MANDATORY SERVICE BULLETIN

IS-29D2/EO-1

Product : IS-29D2 glider serial no.77

Object : Ensuring the Canadian airworthiness requirements

PLATE LOCATION

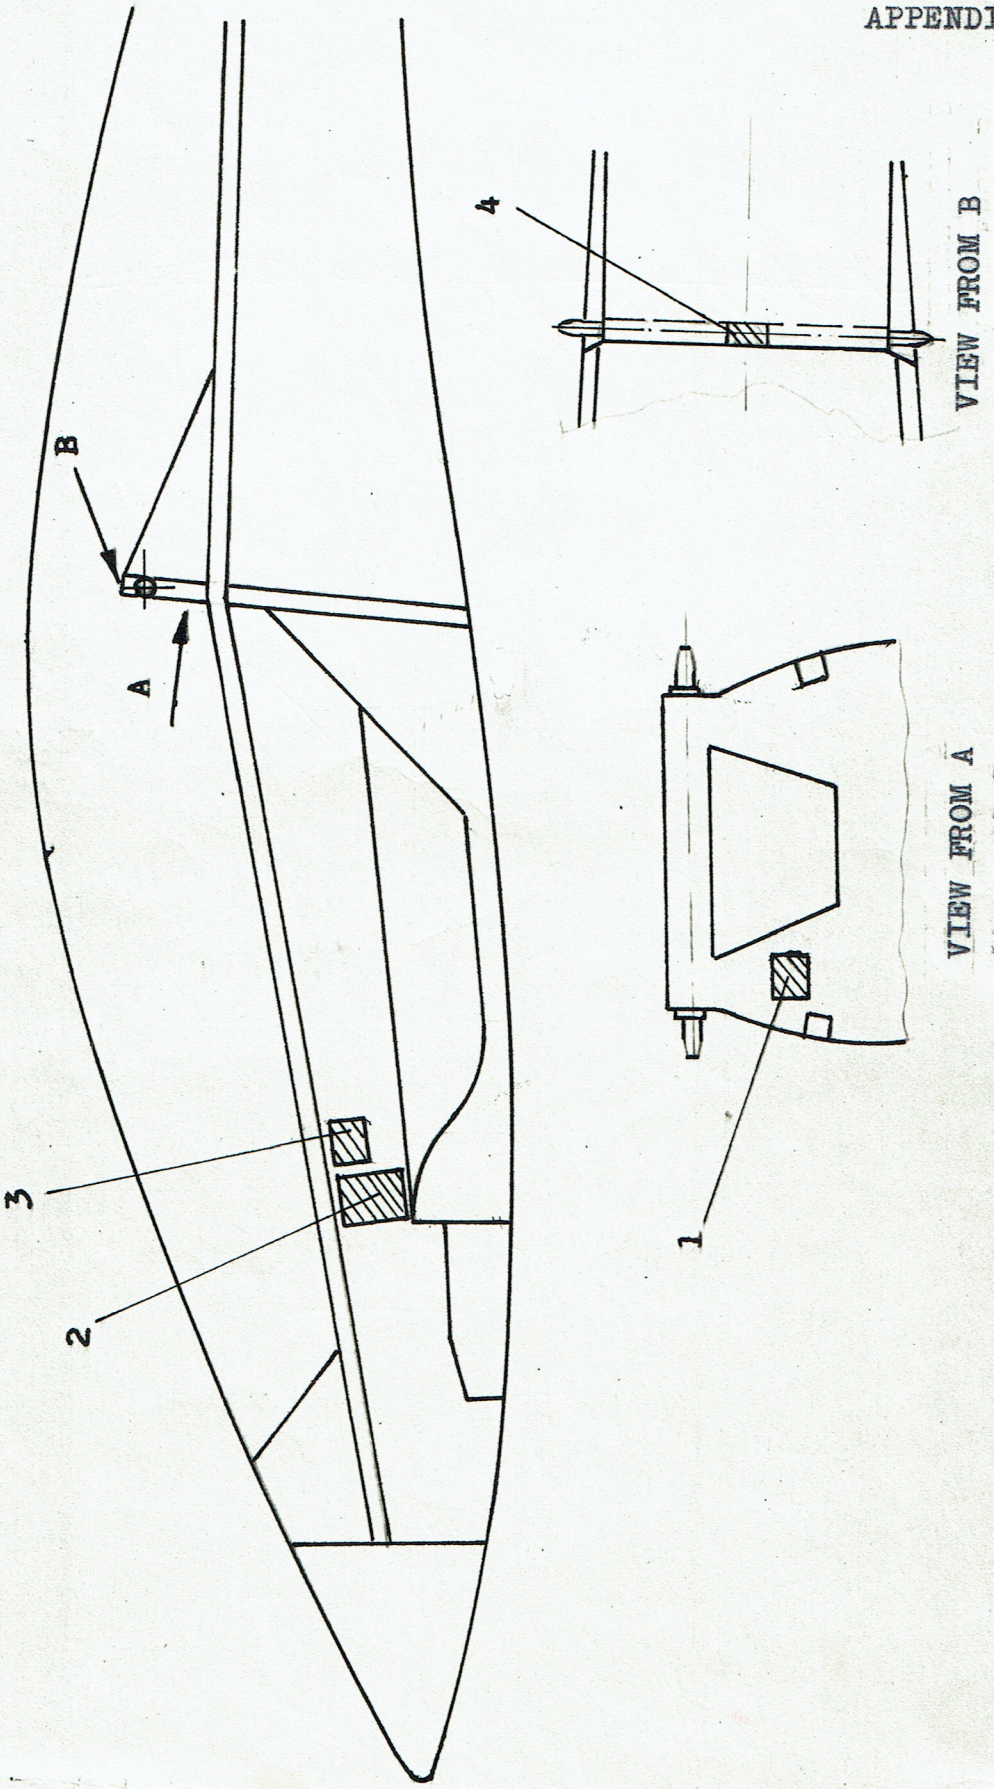
- Remove the placards:
  - data plate
  - speed limiting placard
  - pilot's weight limiting placard
- Glue the placards according to the drawing positions:
  - data plate item 1
  - limitations item 2
  - aerobatic manoeuvring item 3
  - luggage weight item 4
- Replace the Flight and Maintenance Manual 4th issue by the 5th issue.

DATA PLATE

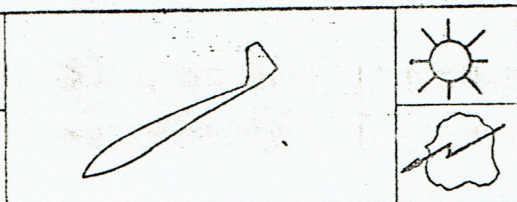
- replacing the fitted manual with a Flight and Maintenance Manual 5th issue;
- replacing the following cockpit placards:
  - data plate
  - speed limiting placard
  - pilot's weight limiting placard

- data plate
- limiting placard
- aerobatic manoeuvering placard
- luggage weight placard.
